Access Compliance Report

Public Rights-of-Way

(Curb Ramps)

Intersection ID: 20587	Main Street: COLONY_RD	Cross Street: FAIRVIEW_RD	Location: NE
ADA ID: 4758923BE29B	Ramp Type: PerpDiag	Initial Pass/Fail: Fail	Overall Compliance: No
Severity Score: 12.5			
Codes/Mitigation Info/Possible Solution		Field Measurements/Component Compliance

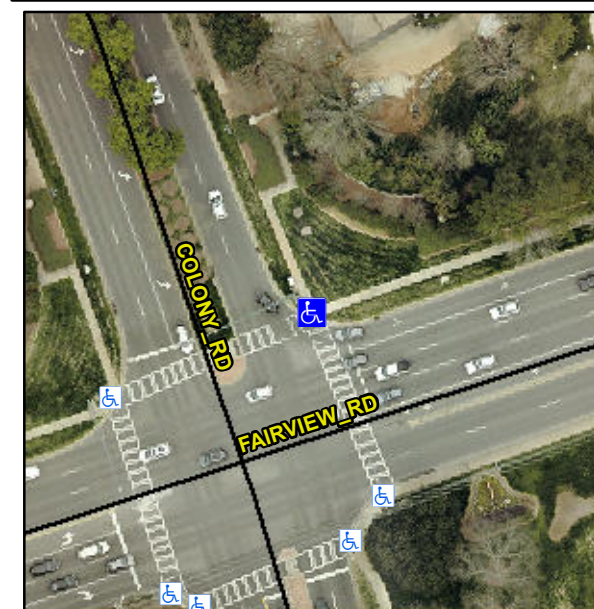
Not Found, R304.2.2

Compliance	Description	Data	Compliance	Description	Data
N/A	Ramp Length (in)	60.0	No	Ramp Slope (%)	9.6
Yes	Ramp Width (in)	48.0	Yes	Ramp XSlope (%)	0.8
N/A	Flare Type LT	N/A	N/A	Flare Type RT	N/A
N/A	Flare Slope LT (%)	N/A	N/A	Flare Slope RT (%)	N/A
N/A	Flare Traversable LT?	N/A	N/A	Flare Traversable RT?	N/A
N/A	Landing Length (in)	N/A	N/A	DWS Provided?	N/A
N/A	Landing Width (in)	N/A	N/A	DWS Contrast?	N/A
N/A	Landing Slope (%)	N/A	N/A	DWS Length (in)	N/A
N/A	Landing X Slope (%)	N/A	N/A	DWS Full Width?	N/A
N/A	Landing Curb? (Y/N)	N/A	N/A	DWS Offset (in)	N/A
N/A	Shared Landing?	N/A			
N/A	Gutter Ponding?	N/A	N/A	Gutter Slope (%)	N/A
N/A	Gutter Lip Ht (in)	N/A	N/A	Gutter X Slope (%)	N/A
N/A	Painted X Walk1?	Yes	N/A	Painted X Walk2?	Yes
	X Walk 1 Direction	To SW		X Walk 2 Direction	To SE
N/A	X Walk 1 Width (in)	112.0	N/A	X Walk 2 Width (in)	109.0
	X Walk 1 Slope (%)	3.3		X Walk 2 Slope (%)	1.6
	X Walk 1 X Slope (%)	0.8		X Walk 2 X Slope (%)	2.5

Remove & Replace Curb Ramp With Two New Directional Ramps or Equivalent.
